Re: 1609 S Park Street, Legistar 78428

Plan Commission
Meeting of August 28, 2013
Agenda #18, Legistar #78428

City of Madison Plan Commission
Meeting of August 28, 2023
Agenda #18, Legistar #78428

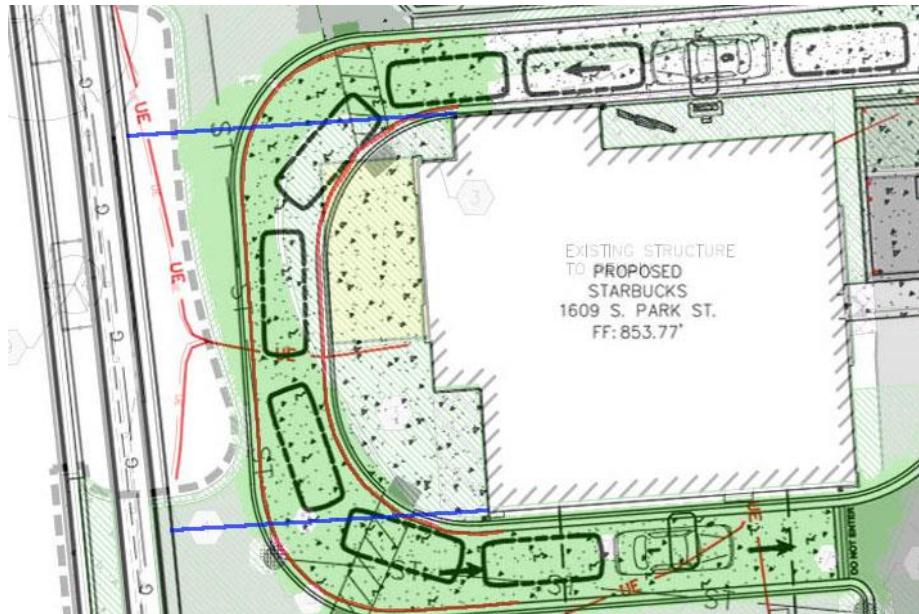
"Per the revised letter of intent dated August 23, 2023 the coffee shop would be a drive-thru only location with no walk-up service. In discussing the change with the applicant they noted that the walk-up service was removed due to potential pedestrian-vehicle conflicts." (Page 3 of the Staff report.)

- Plan Commission is being asked to approve a drive-thru coffee shop, not a coffee shop with a drive-thru.
 - A coffee shop is a permitted use, a drive-thru is an accessory use which requires conditional use approval. An accessory use is a "use on the same lot with, and of a nature *customarily subordinate to, the principal use or structure, and serving the occupants of the principal use or structure.*" MGO 28.211 (emphasis added)

- The drive-thru will not be subordinate to the principal use. Rather, the drive-thru will be the principal, and only, use.
- Even though Starbucks will not have walk-up service, the provisions of MGO 28.151 still apply. In particular: "Site design shall accommodate a logical and safe vehicle and pedestrian circulation pattern."

- The area between the building and the street is being substantially altered. Below are images of Sheet C201 (site plan) overlaid on Sheet C101 (demolition plan). With this amount of change, it is hard to argue that the nonconforming use is being continued.

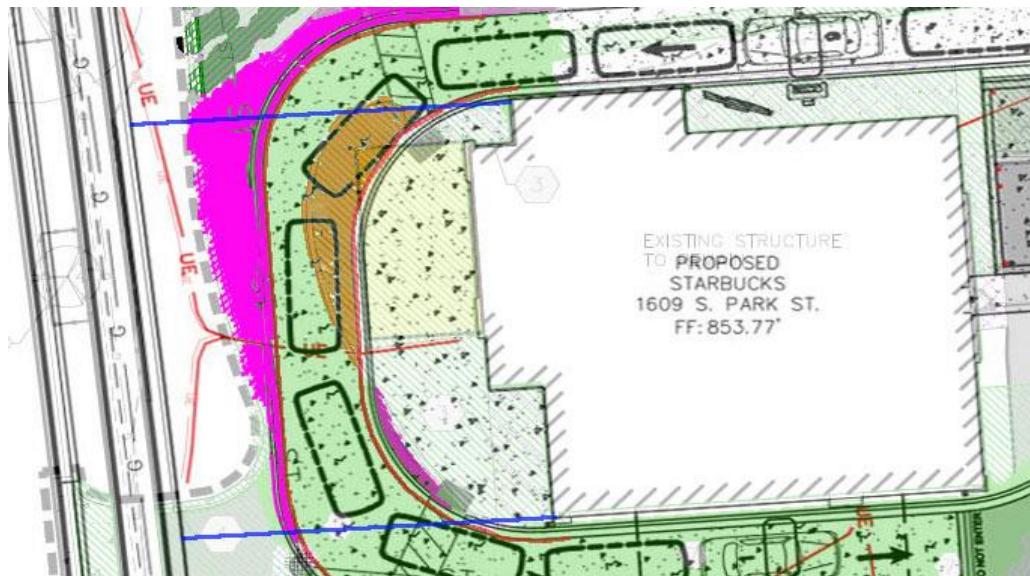
The light green background is the current drive.

The red lines are the new vehicle access sales and service drive

Fuchsia is the portion of the current drive that will not become part of the new vehicle access sales and service drive.

Rust is the area which is not part of the existing drive but which will become part of the new vehicle access sales and service drive.
